## Pre-Application Meeting PRE 24-04 Agenda

Thank you for joining staff for pre-application meeting PRE-24-04 to discuss the proposed addition to Arthur Academy at 575 Gatch St. (Tax Lot 051W18AA05700), and 431 Gatch St. (Tax Lot 051W18AA06000). The two properties combine to around 11 acres within the Single Family Residential (RS) zoning district. Section references throughout this agenda are to the [Woodburn Development Ordinance \(WDO\)](#).

Arthur Academy - Proposed Modular Building – 575 Gatch Street, Woodburn, OR 97071

*Submitted proposed site plan*

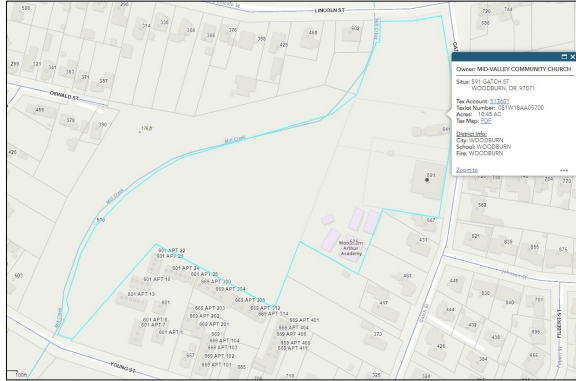
**Overview:** The site shown on the submitted site plan is on another property (shown outlined in red above). The Mid-Valley Church owns it, but it is a separate lot, therefore, either a Lot Consolidation or Property Line Adjustment will be necessary to place another accessory structure at this location. Additionally, schools are a Conditional Use (CU) within residential zones. The initial Conditional Use application for Arthur Academy was approved in 2006. This would be an expansion, and would therefore trigger another Conditional Use review by the Planning Commission.

Figure 3.01E – Access Street / Commercial Street

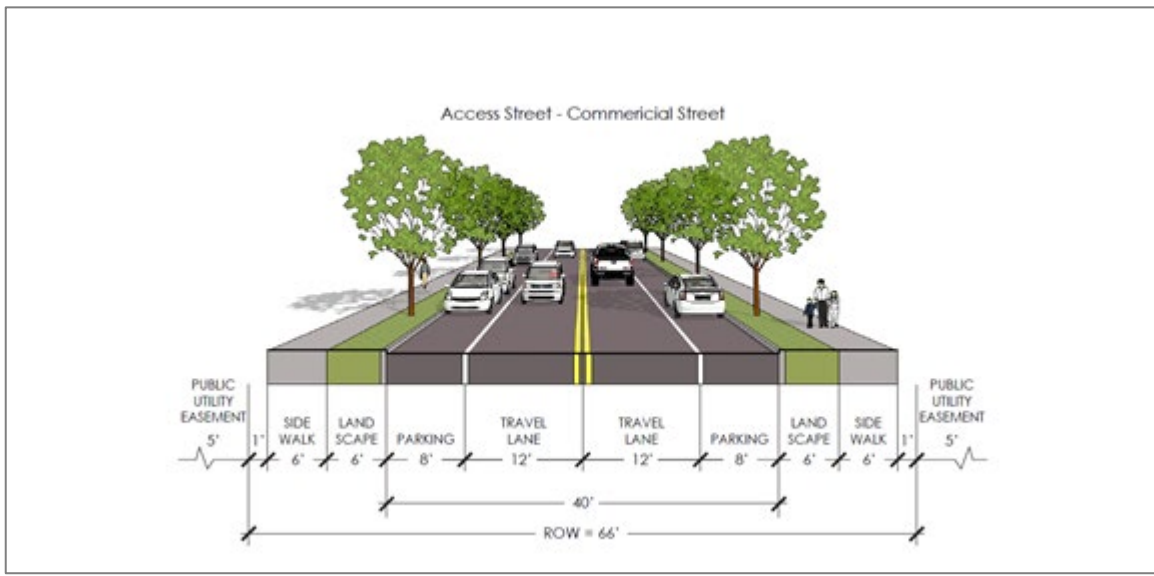
Gatch St: An Access street, the standard cross-section is Figure 3.01E.

The standard requirement would be to apply Figure 3.01E, which appears to require a 13ft ROW dedication along the eastern property line and a streetside PUE along this ROW strip. As allowed by 3.01.04B1, the applicant may submit a [Street Adjustment](#) application in order to dedicate the ROW and the streetside PUE but not to improve the street to match the cross-section in Figure 3.01E (or some other combination thereof).

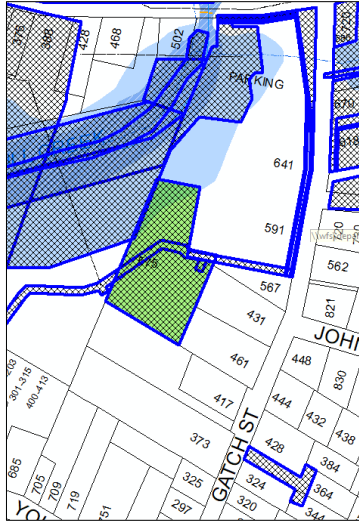
- a. Existing ROW is 40ft, therefore, 13' dedication is required.
- b. It does not appear that a streetside Public Utility Easement (PUE) exists per 3.02.01B. Dedicate a PUE: Min width is 5ft, max is 8ft.

- c. Per 3.01.03C2, construct a 6ft sidewalk and 6ft landscape strip along the frontage to match Figure 3.01E.
